**APPLICANT'S MITIGATED PROJECT ANALYSIS:
LAETITIA AGRICULTURAL CLUSTER PROJECT REVISED RECIRCULATED DEIR**

**RE: Comments on Laetitia Agricultural Cluster Subdivision DEIR
SUB2003-00001 (Tract 2606), SCH # 2005041094**

Subject: Response to WRAC Subcommittee Draft Report on Laetitia Agricultural Cluster RRDEIR.

Figure 7
Updated Geosyntec Figure 18
Laetitia Agricultural Cluster

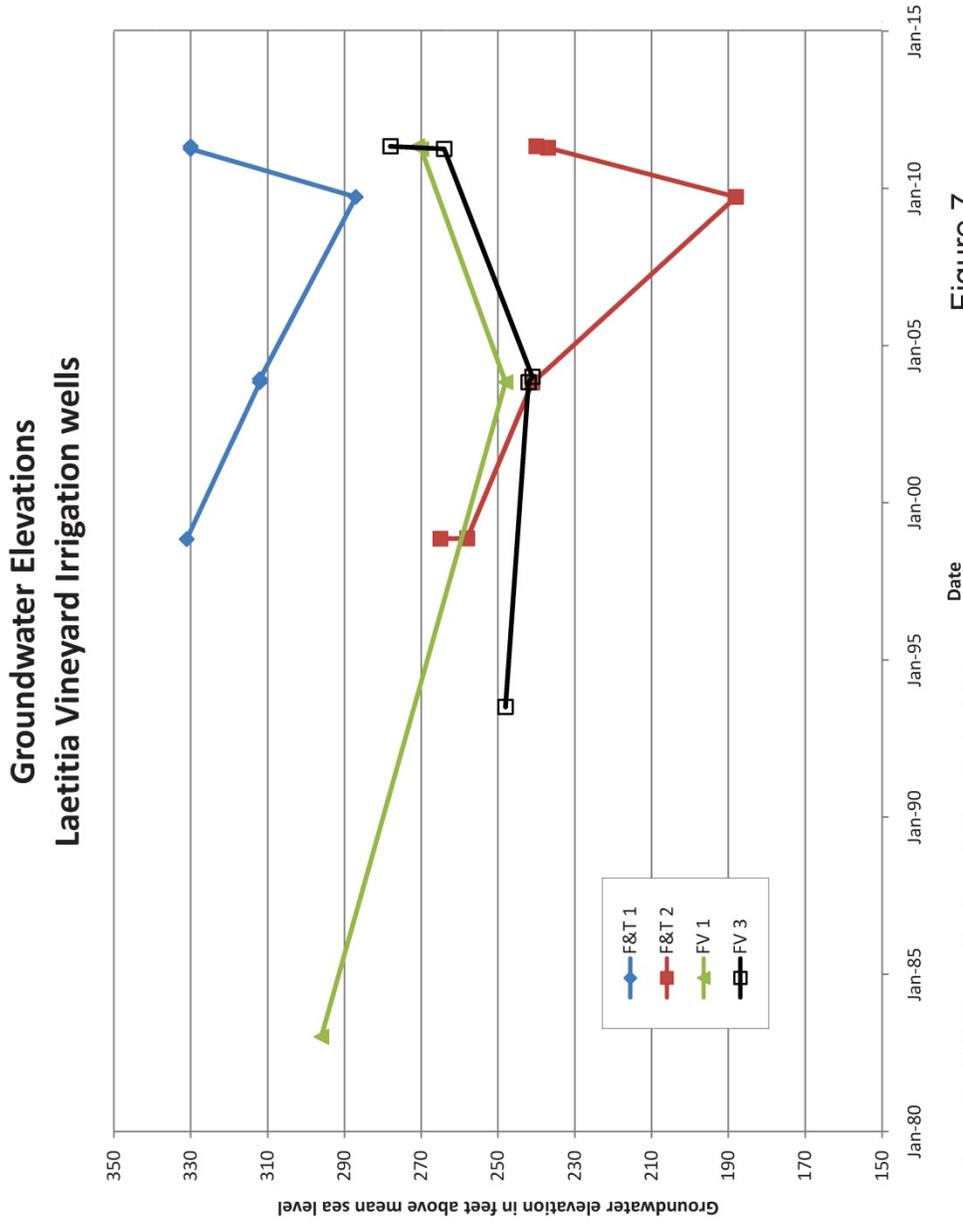
Appendix H1, figure 18, shows F&T 1 dropped 40 ft. in a decade, FVW-1 dropped 40 feet in 20 years, F&T 2 dropped 80 ft. in 10 years, and FVW-3 about 10 ft. in 10 years. This suggests that an overdraft condition already exists in the area, that the existing production for the vineyard is unsustainable in the long term, damaging to Los Berros Creek ecosystems, and reducing recharge to the Arroyo Grande Subarea aquifers. (page 9)

The RDEIR updates agricultural well production for 2011 but for some reason does not update Figure 18 (water levels), which only includes measurements through September 2009 (drought). CHG has attached an updated figure to reflect spring 2011 measurements (within the time frame of RDEIR analysis). As shown in the updated figure, water levels have recovered following the recent drought, indicating the aquifers in question receive recharge and are not being mined (attached Figure 7).

An update of the above-referenced Figure 18 that included Spring 2011 measurements was provided to the EIR consultant and to the WRAC that shows water level recovery at the vineyard wells and does not indicate overdraft conditions (attached).
